Value Engineering Study

**Cousins Pumping Station Complex
Jefferson Parish, Louisiana**

**U.S. Army Corps of Engineers
New Orleans District**

SUBJECT: Value Engineering (VE) Study for the West Bank,
Vicinity of New Orleans, LA Hurricane Protection Project -
Cousins Pump Station Complex

IDENTIFICATION NUMBER: 12

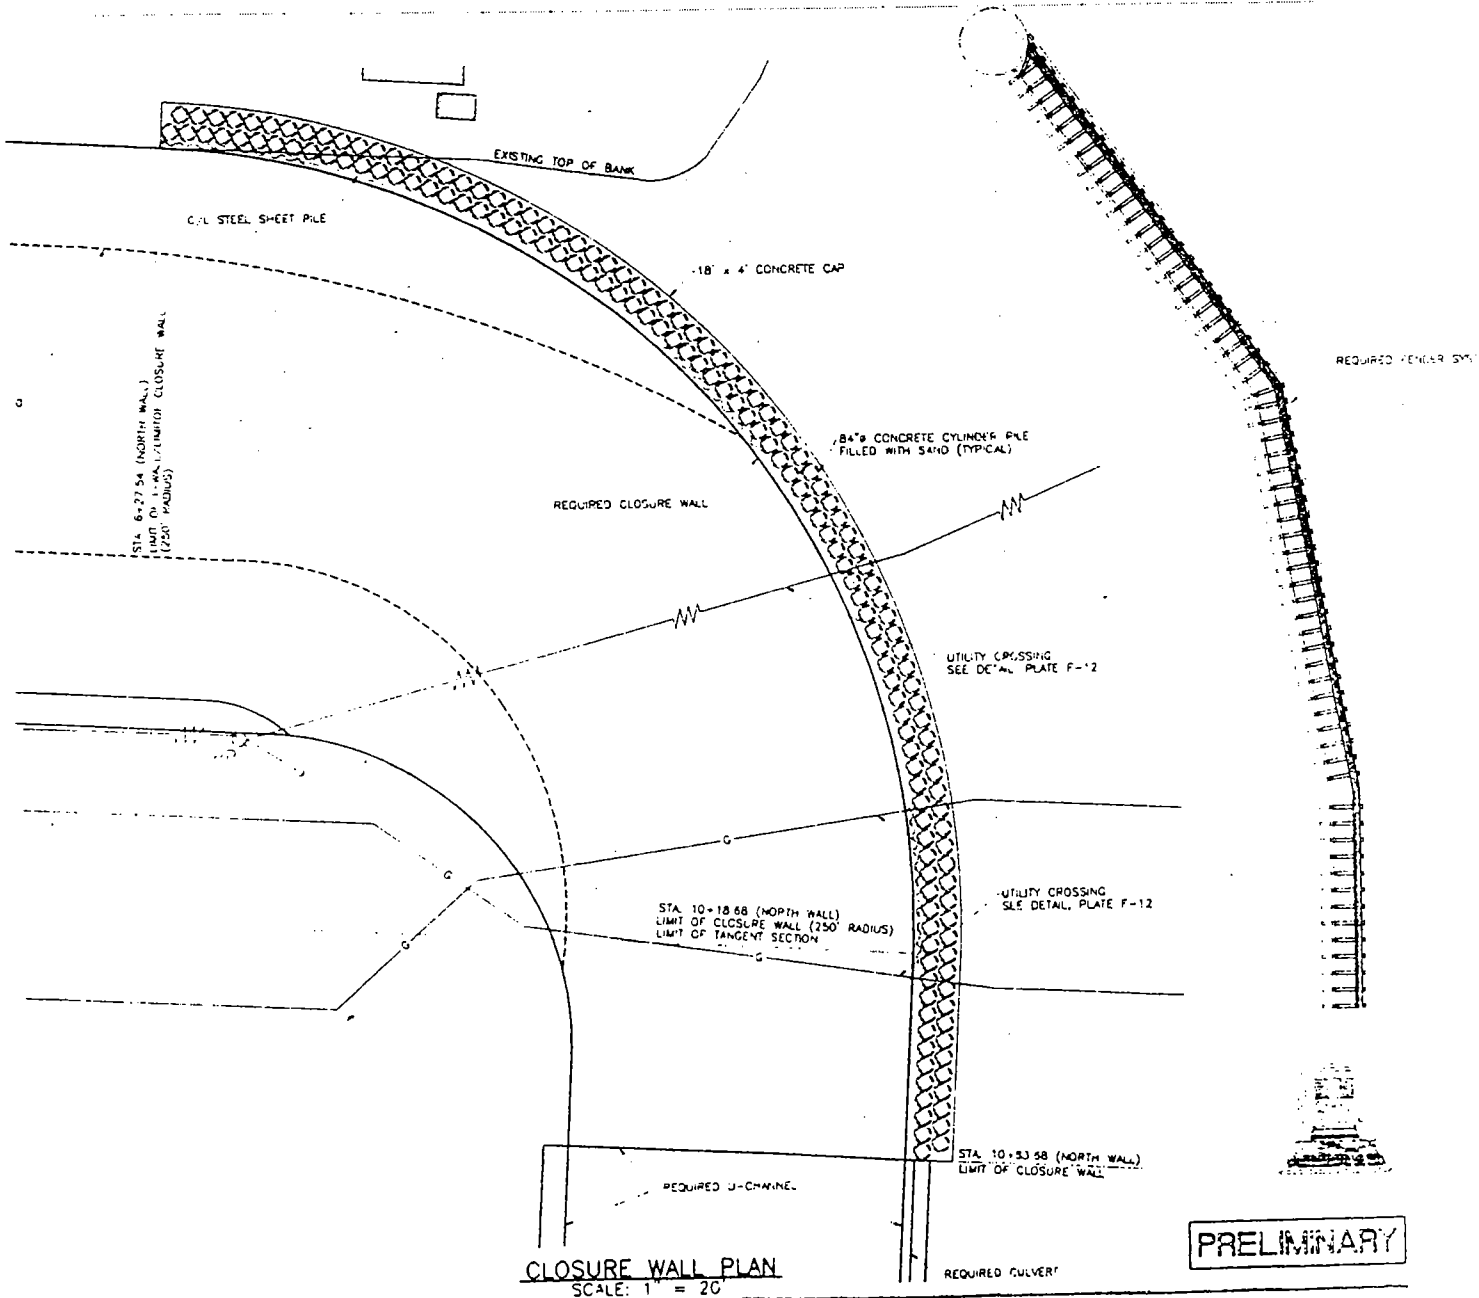
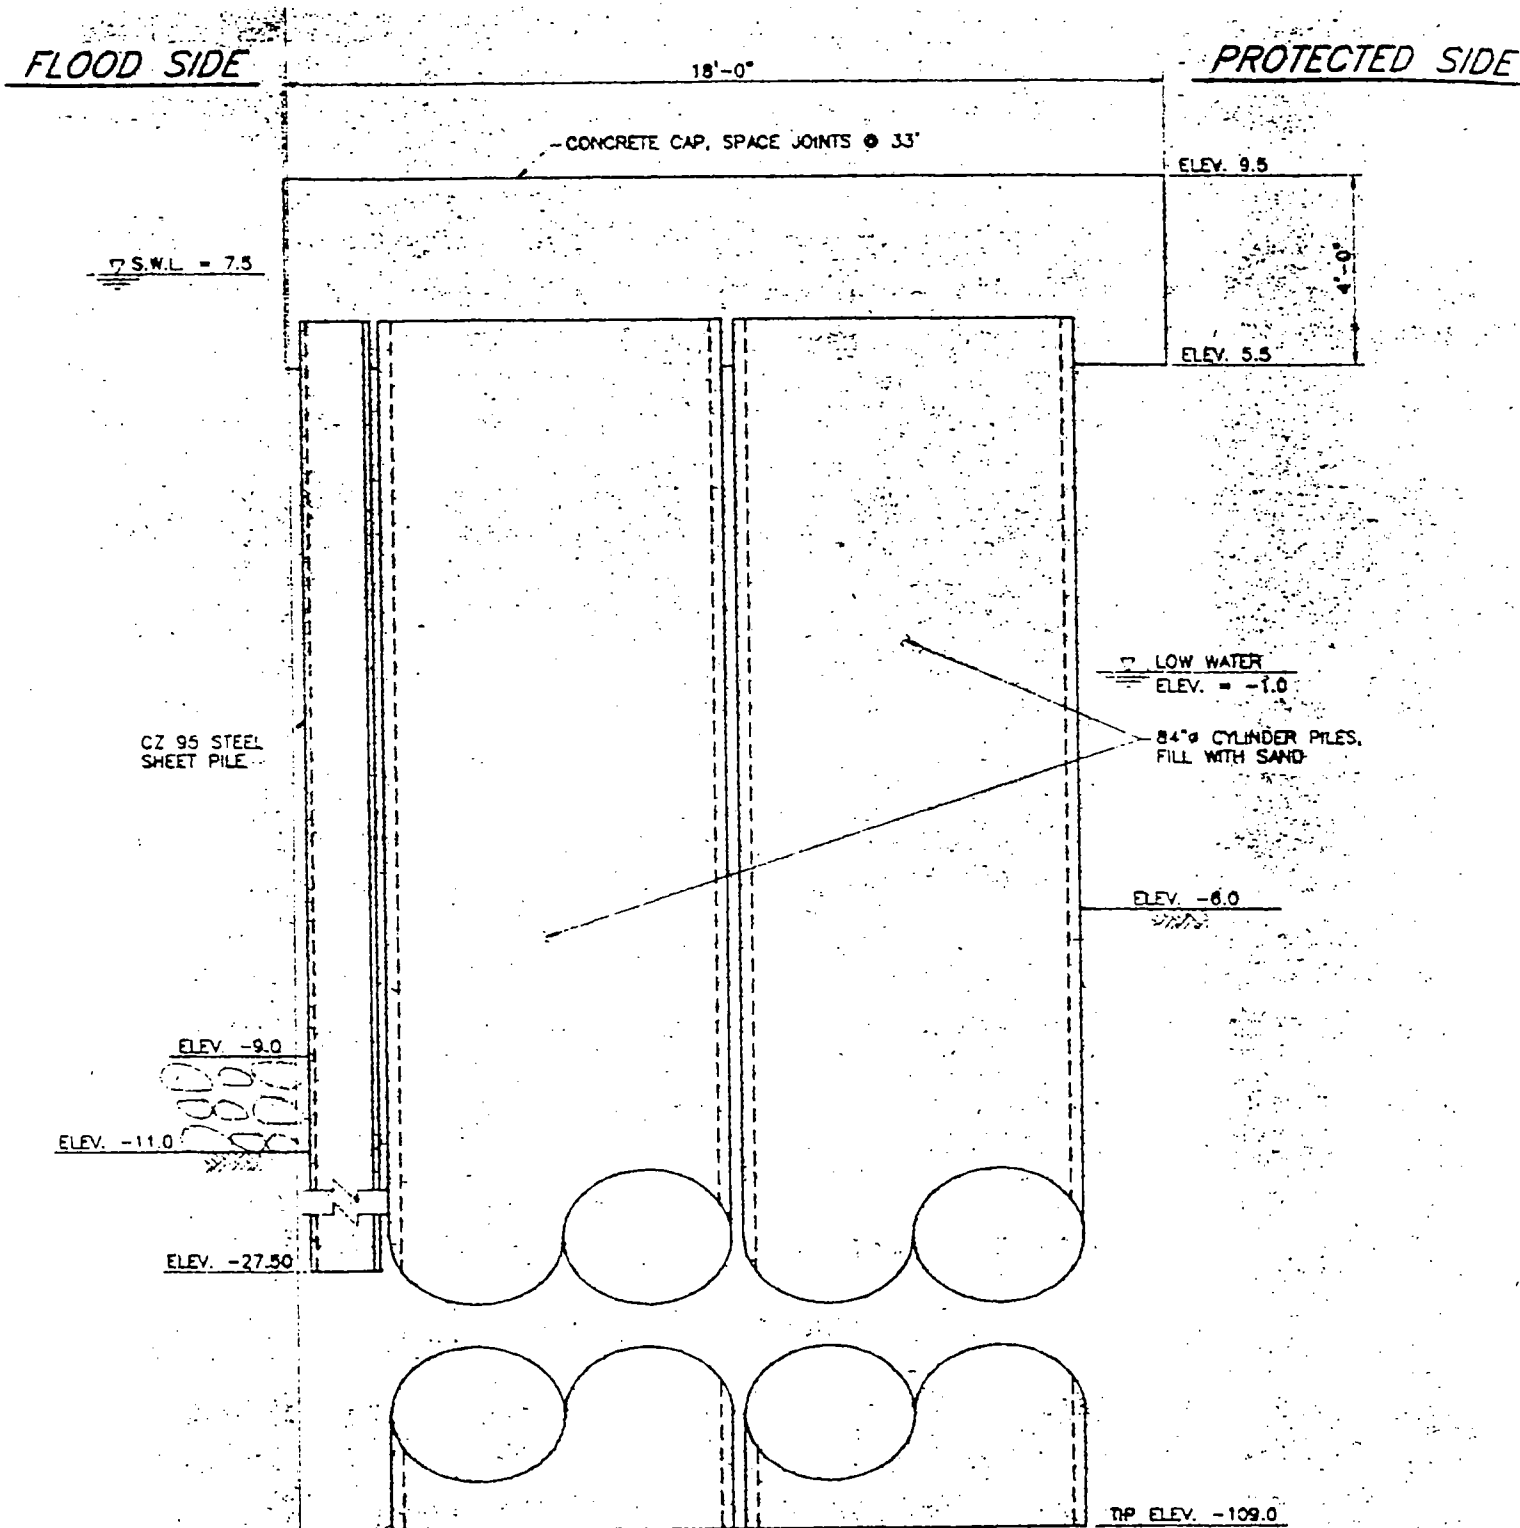
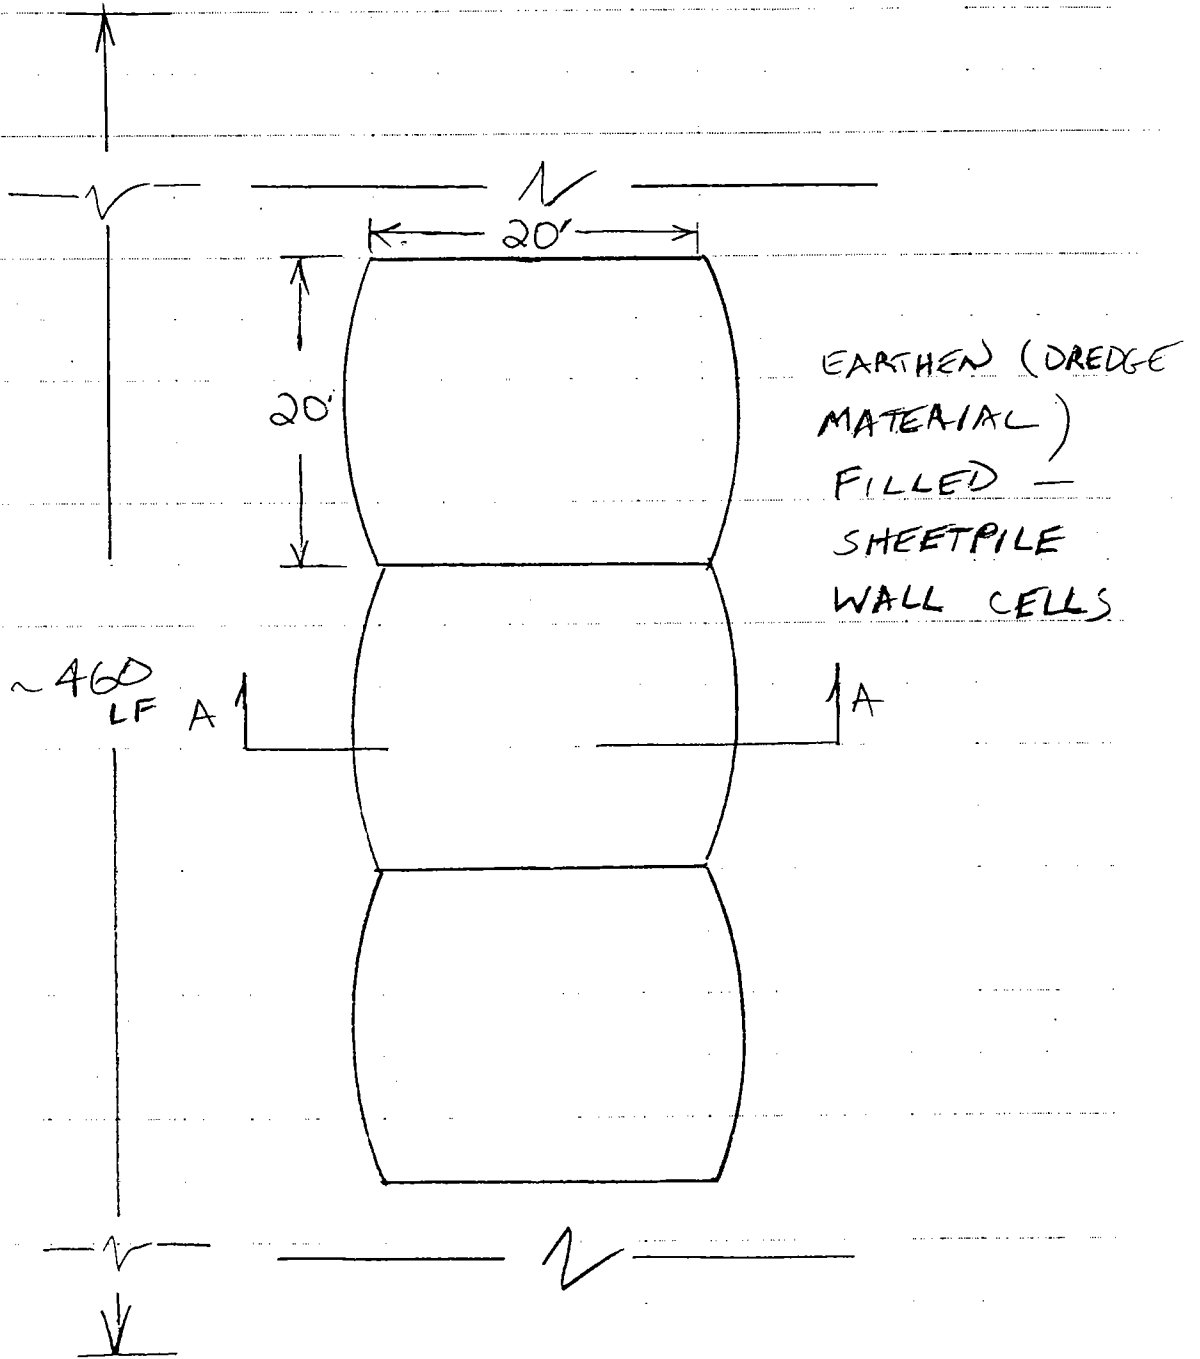
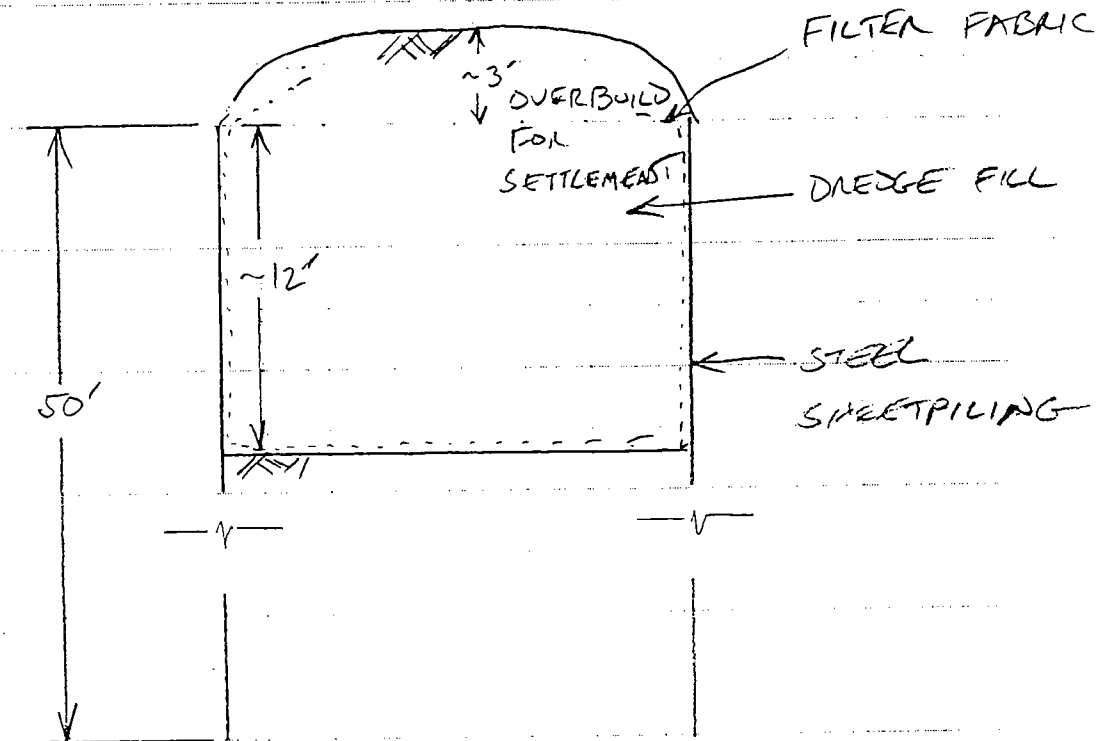
The discharge channel outer barrier wall consists of dual 84-inch diameter concrete pile piling and one row of steel sheet piling.

Construct a discharge channel outer barrier wall using sheet pile - earthen fill cells.

Filled cell walls are a much more commonly constructed structure than the proposed large diameter pipe - pile wall. This design appears to be significantly easier to construct and repair if and when necessary. The cell wall also appears to be a better water barrier as compared to the existing design given two rows of locked sheet piling plus ten feet of fill versus one row of locked sheet piling with 84-inch piling that will have significant gaps.
